Subject: TIB 45-32, Oil Fill Support Bracket Campaign

Kenworth has identified an assembly process that may have resulted in failure to install an engine oil fill tube support bracket and clamp on the chassis listed with this letter. If this support is missing, there is increased possibility for bending or breaking of the engine oil fill tube.

Illustration of support bracket and clamp on engine oil fill tube

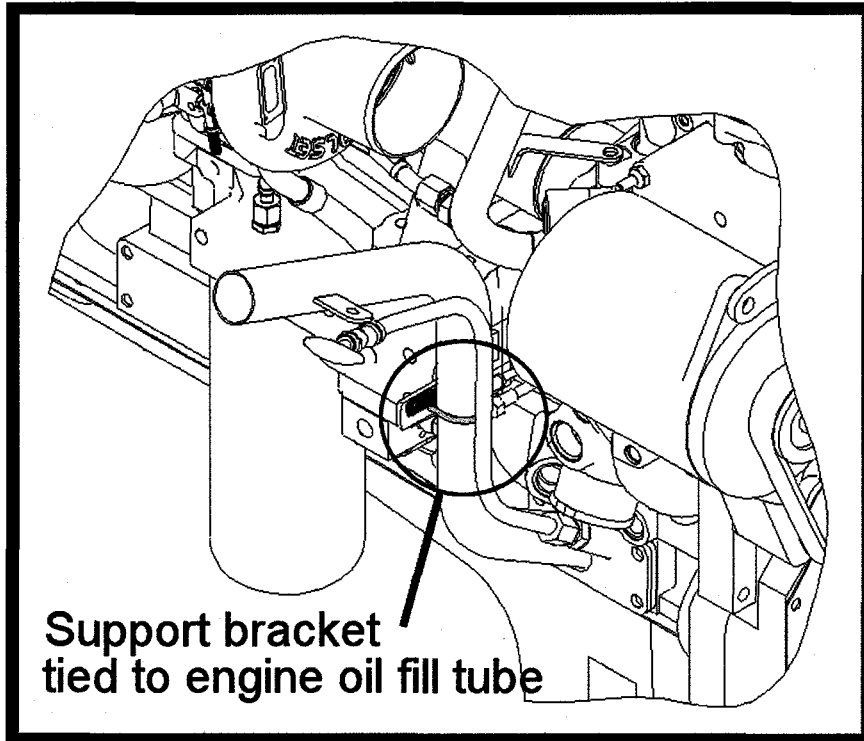
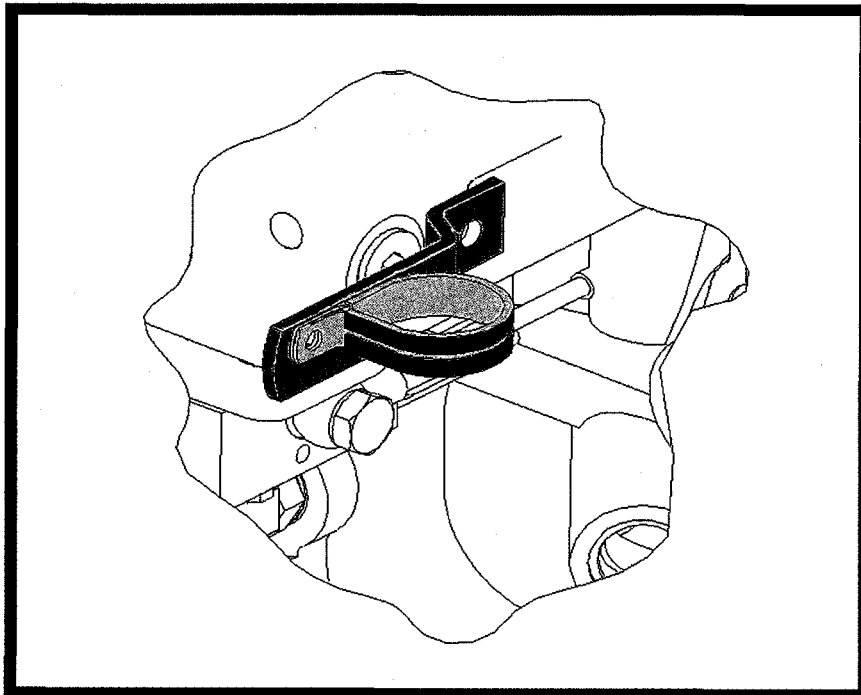
Attached is an illustration of the oil fill tube support that should be installed.

Customers of chassis listed should inspect their engines or may elect to have any Kenworth dealer Service department make that inspection. If the support was not installed as original equipment, your Kenworth dealer will install parts at no charge to you. This offer is made for repairs completed by December 31, 2008.
